# HISTORIC AND DESIGN REVIEW COMMISSION

March 20, 2024

**HDRC CASE NO:** 2024-109  
**ADDRESS:** 421 E COMMERCE ST  
**LEGAL DESCRIPTION:** NCB 148 BLK LOT 2 & 3  
**ZONING:** UZROW, H, RIO-3, D  
**CITY COUNCIL DIST.:** 1  
**DISTRICT:** Alamo Plaza Historic District  
**APPLICANT:** Ron Bechtol/Ron Bechtol, Architect  
**OWNER:** Wallace Rogers III/SCHULTZE & RILLING BUILDINGS  
**TYPE OF WORK:** Replacement of the exterior stair on the river side, installation of new umbrellas and patio elements, painting  
**APPLICATION RECEIVED:** March 01, 2024  
**60-DAY REVIEW:** April 30, 2024  
**CASE MANAGER:** Edward Hall

NEW STAIR at BOUDRO'S EXPANSION  
 417 E. Commerce Street River Level

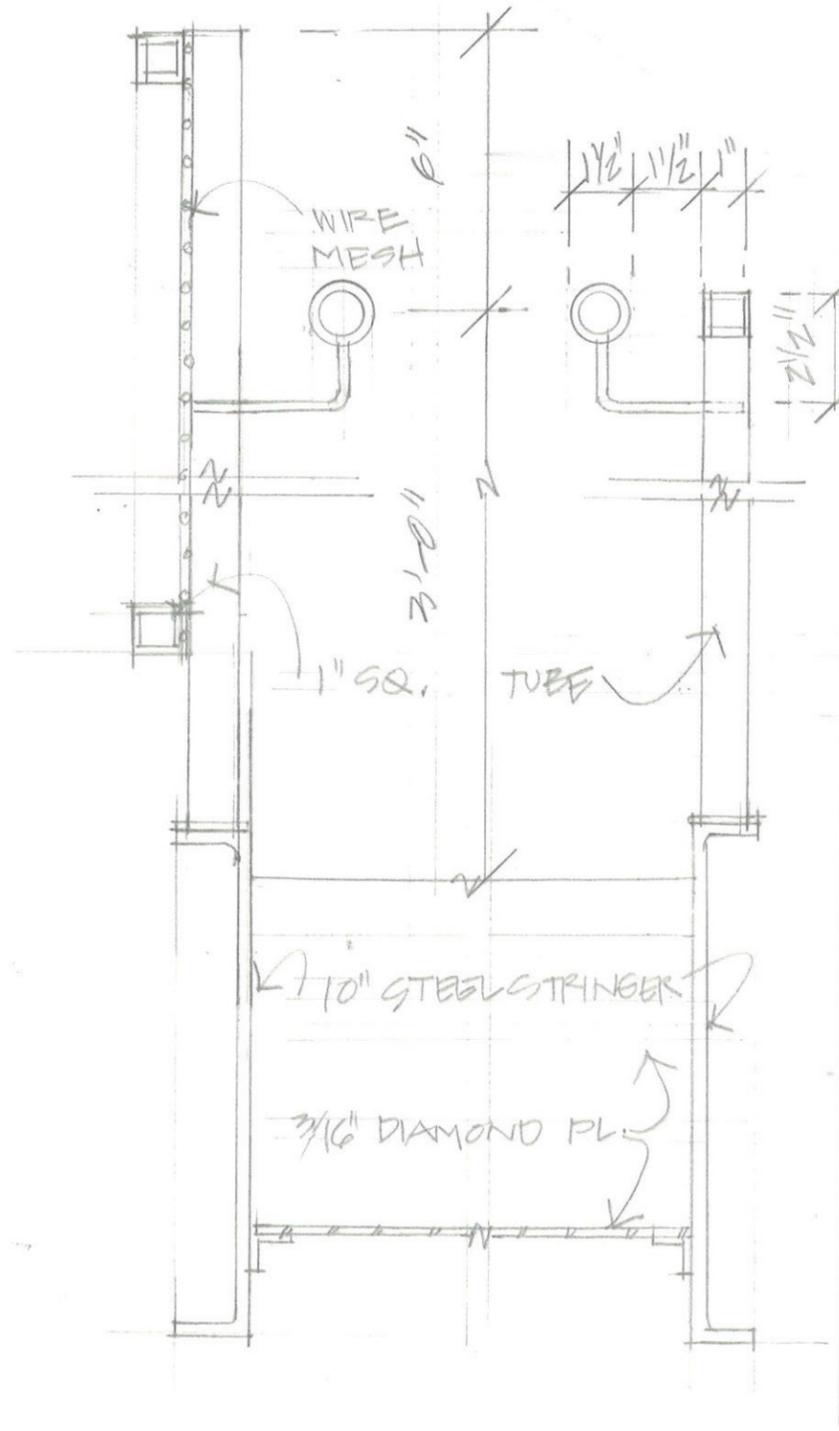
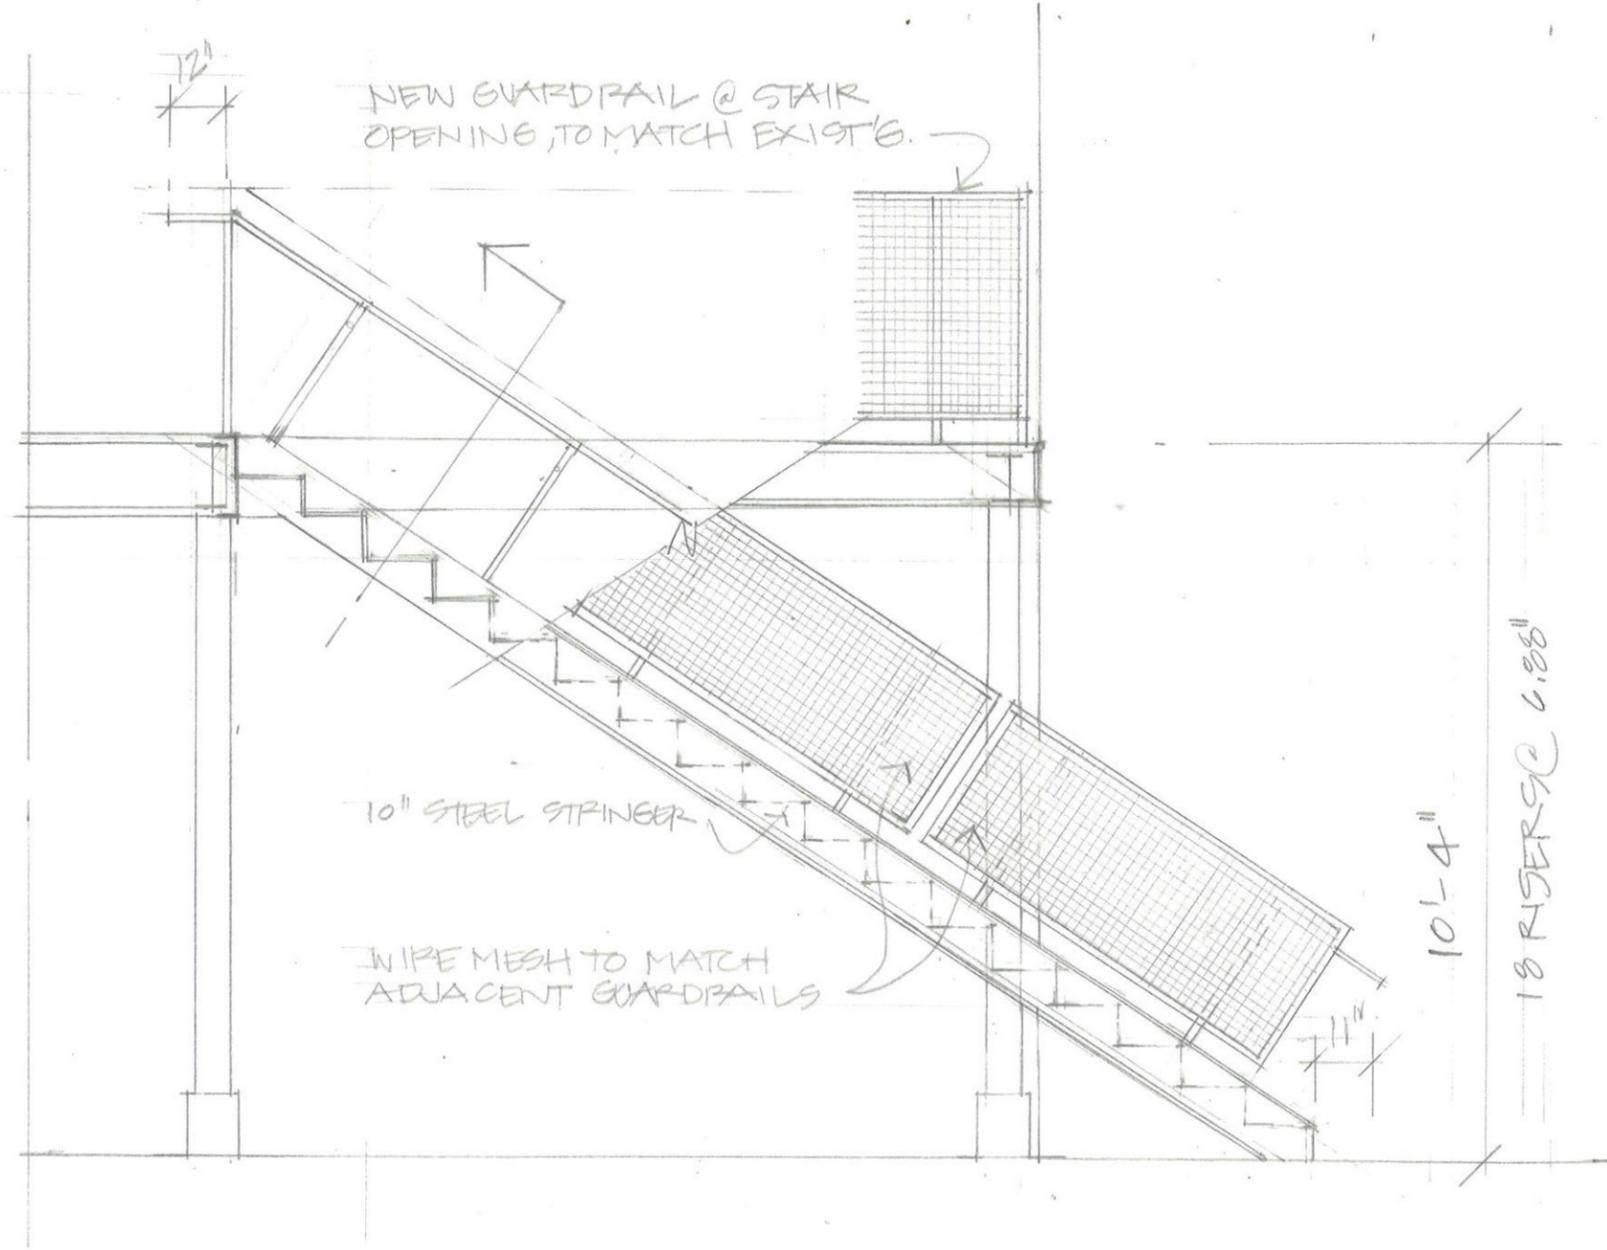
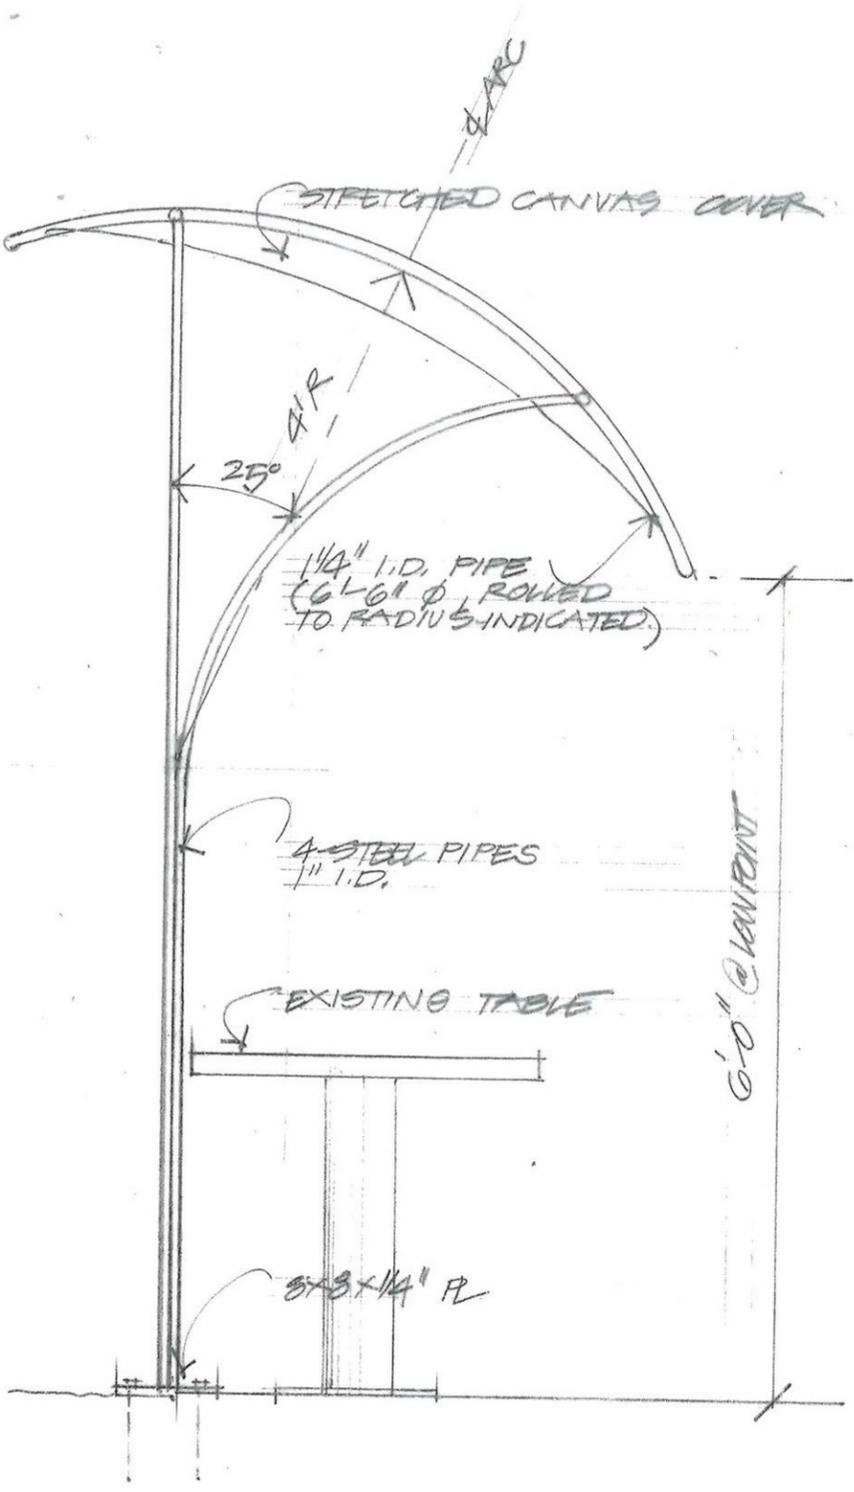
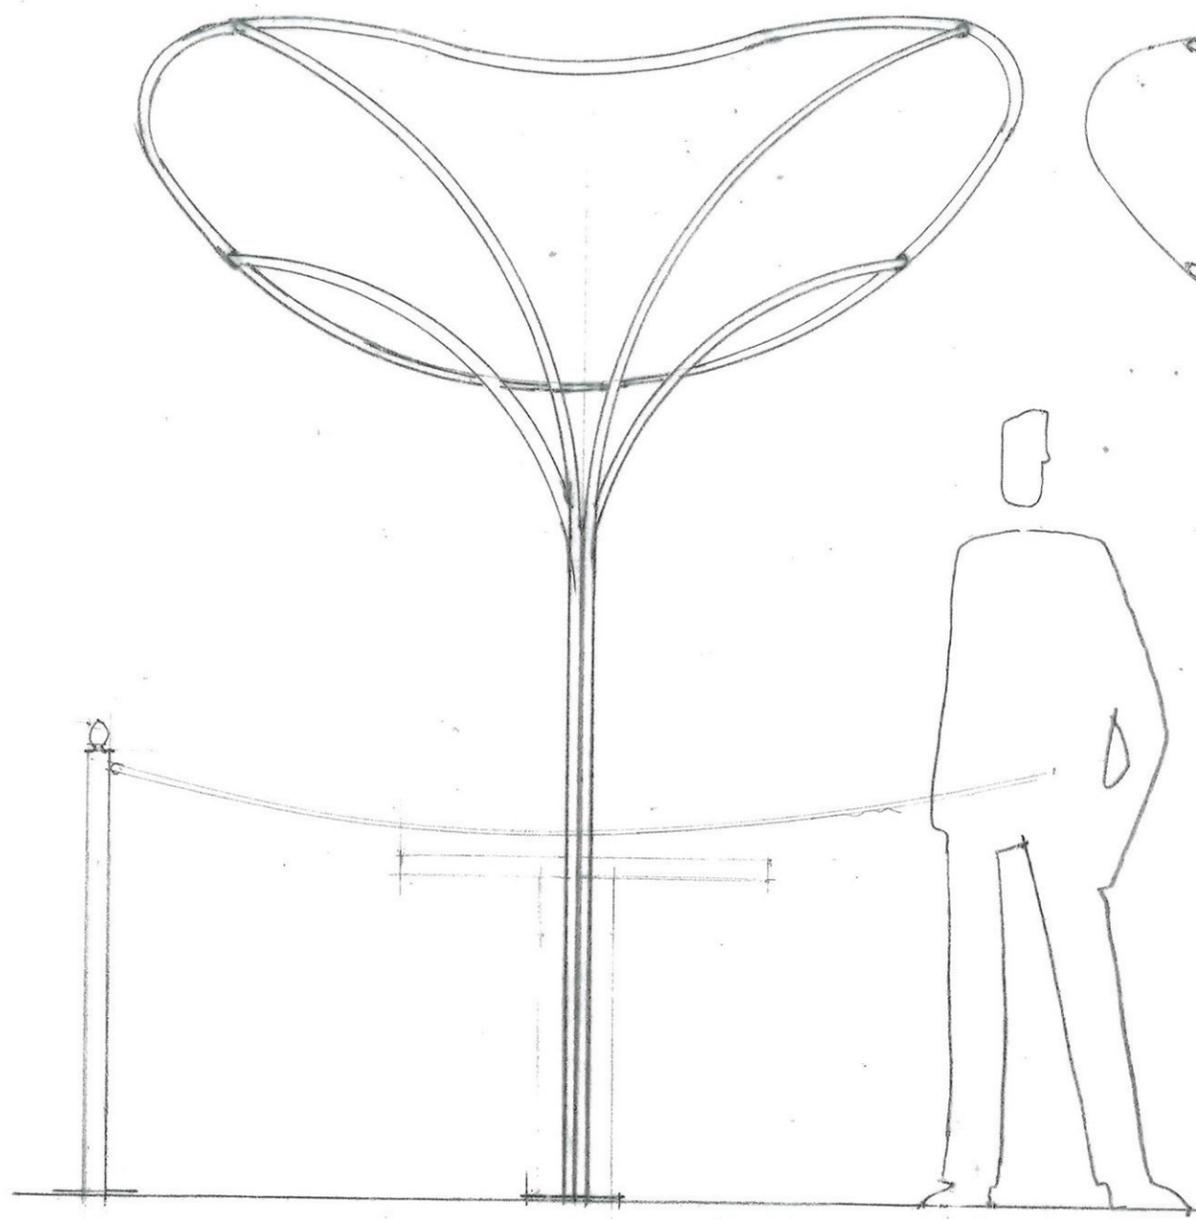
- e. STEEL STAIR CONSTRUCTION – The applicant has proposed to remove an existing steel stair and construct a new steel stair in a location further within the site. This modification will create more site space and remove an existing barrier and obstruction (the stair) from being adjacent to the public right of way. The proposed stair will feature diamond plate risers and metal guardrails that match the existing stairs' guardrails. Staff finds the proposed stair to be appropriate and consistent with the UDC regarding its materials and design. Staff finds that the finish of the stair should be consistent with the finish of the existing stair.

1. Staff recommends approval of item #1, the installation of patio furniture and umbrellas based on finding c with the following stipulations:
  - i. That all patio furniture be installed in a manner that does not block the pedestrian right of way at the River Walk.
  - ii. That all patio furniture and umbrellas be free of signage and branding.
2. Staff recommends approval of item #2, painting, based on finding d with the stipulation that unpainted masonry elements (brick, cut stone, cast stone, and natural rock façade elements) remain unpainted.
3. Staff recommends approval of item #3, the construction of a new steel stair based on finding e with the stipulation that the finish of the stair and its elements be consistent with the finish of the existing stair.
